**SUBJECT: SAN ONOFRE NUCLEAR GENERATING STATION – NRC CONFIRMATORY  
ACTION LETTER RESPONSE INSPECTION 05000361/2012009 AND  
05000362/2012009**

IR 05000361/2012009; 05000362/2012009; 12/03/2012 – 06/07/2013; San Onofre Nuclear Generating Station; Confirmatory Action Letter Response Inspection.

Figure 4: U-Bend Gap Velocities

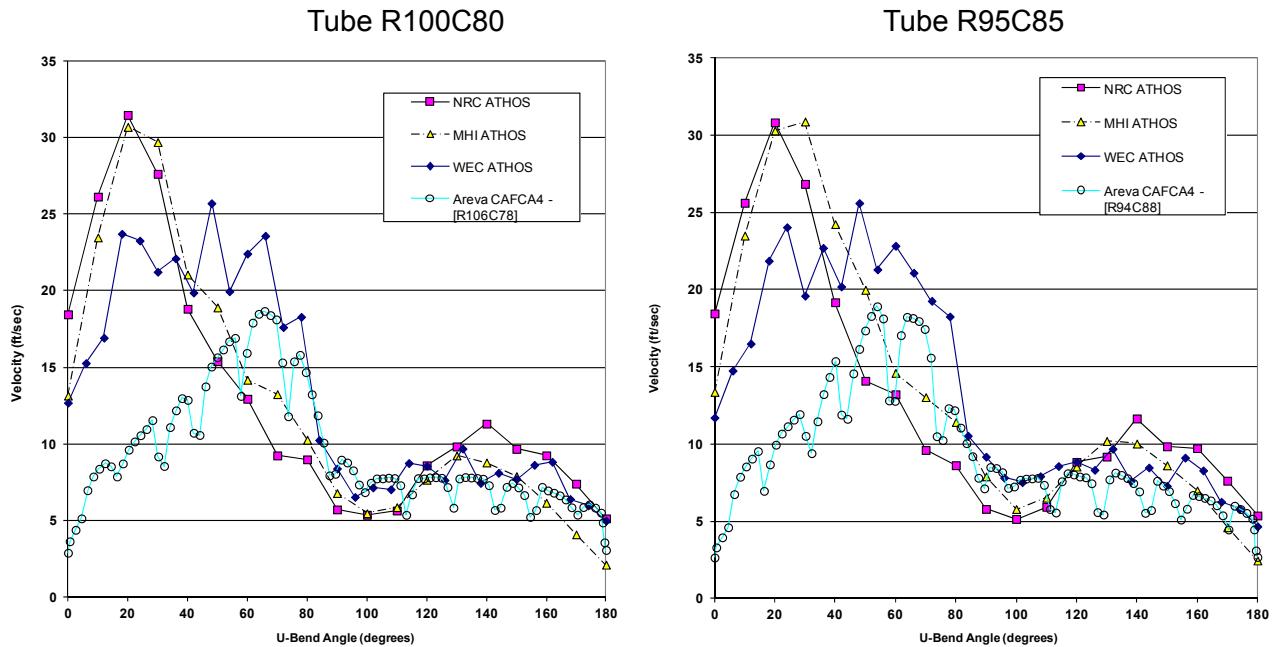
The NRC and Mitsubishi results show the higher peak void fractions, which also peak at a lower location along the U-bend as compared to the Westinghouse and AREVA results. At higher angles along the U-bend, the void fraction predicted by each code tends to merge, and the remainder along the cold side tends to show very similar trends. As expected, comparisons of fluid density show similar trends as the void fraction. Dry saturated steam at about 850 psia has a density of about  $2.0 \text{ lb}_m/\text{ft}^3$ , and the NRC, Mitsubishi, and Westinghouse results predict that there are significant areas in the U-bend, in the affected region, where velocities are high and steam is nearly dry. Peak velocities and void fraction support the tube-to-tube wear patterns found in the Unit 3 steam generators. The inspectors concluded that the ATHOS code models are adequate to predict the approximate location and magnitude of the high void fraction and velocity, which are the key contributors to tube-to-tube wear found in the U-bend region.

Fig. 1 Critical velocity for onset of FEI as a function of void fraction.

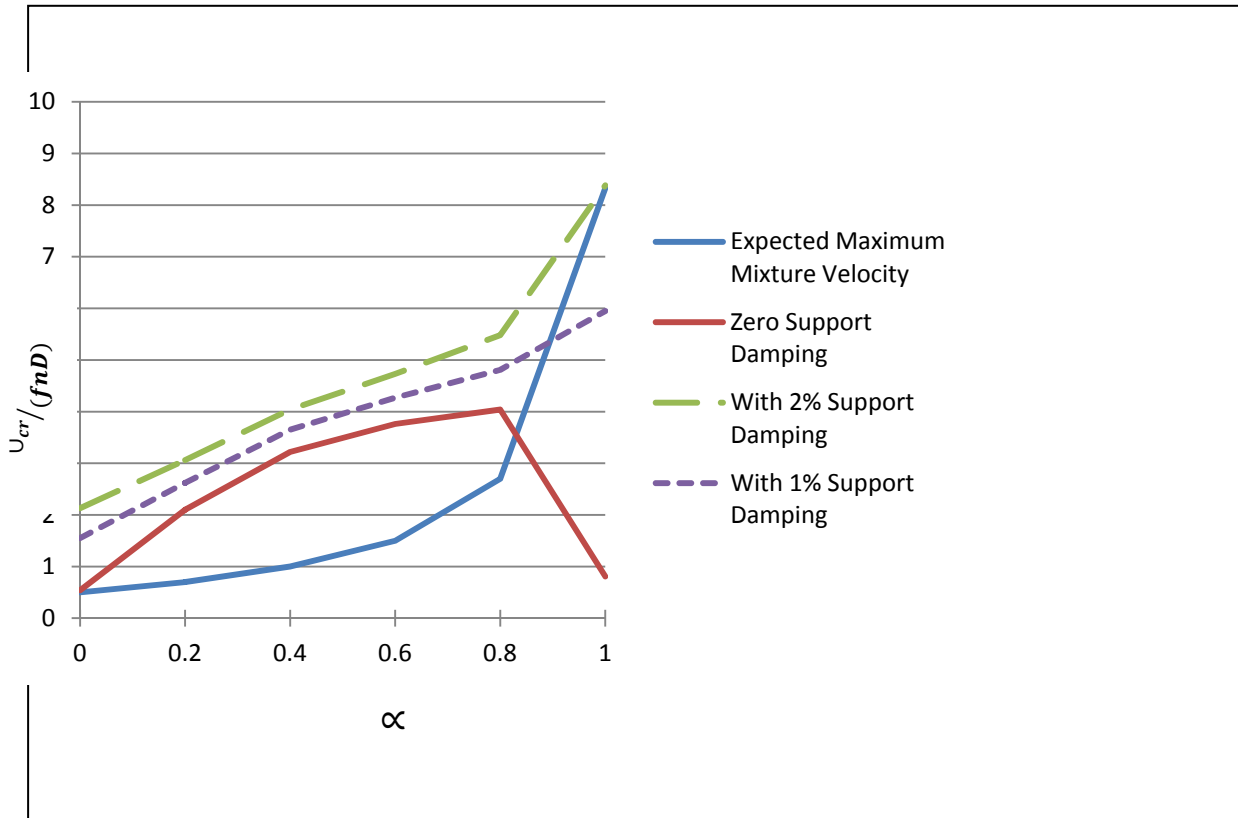
The calculated dimensionless critical velocity for onset of FEI is plotted in Fig. 1 as a function of void fraction, with or without support damping. In this figure the expected two phase mixture velocity through the steam generator (RSG) tube bundle is also plotted as a function of  $\alpha$  for an assumed two phase mass flow rate of  $65 lbm / ft^2 / sec$  or  $315 kg / m^2 / sec$  and natural frequency of  $34 sec^{-1}$ . It is noted that for void fractions less than 0.8 in the U-bend region of the bundle (for cross flow), the critical velocity for onset of instability is higher than the mixture velocity. As such probability of onset of FEI will be low. However, for void fractions greater than 0.8, the mixture velocity can be substantially higher than the critical velocity, indicating a strong possibility of occurrence of FEI. In RSGs for Units 2 and 3, there is a significant area in the upper U-bend region where calculated void fractions exceed 0.8. When support damping of 1% and 2% is included, the predicted dimensionless critical velocity for onset of FEI increases for all values of  $\alpha$ . However, the increase is substantial for high void fractions (greater than 0.8) because now the support damping dominates viscous and two phase damping. With support damping of 1%, the two phase mixture velocity can

exceed the critical velocity for onset of FEI when the void fraction approaches unity. (Although this is not the case for the results plotted in Fig. 1 when support damping of 2% is included in the calculations.) Thus to reduce the propensity of FEI it is essential that very high void fraction regions ( $\alpha \approx 1$ ) in the upper U-bend region of RSGs should be avoided. Figure 1 can be used to determine for individual tubes or clusters of tubes the potential for FEI in Units 2 and 3 RSGs. It should also be noted that lack of contact forces and damping due to anti-vibration bars may be the dominant reason for existence of FEI and severe tube damage in Unit 3 RSGs. As a result of FEI, initially out-of-plane vibrations are expected to occur in the lift direction normal to plane of the tubes. However, this instability in the absence of restraining force from anti-vibration bars can excite in-plane vibration that can be the cause of tube to tube damage.
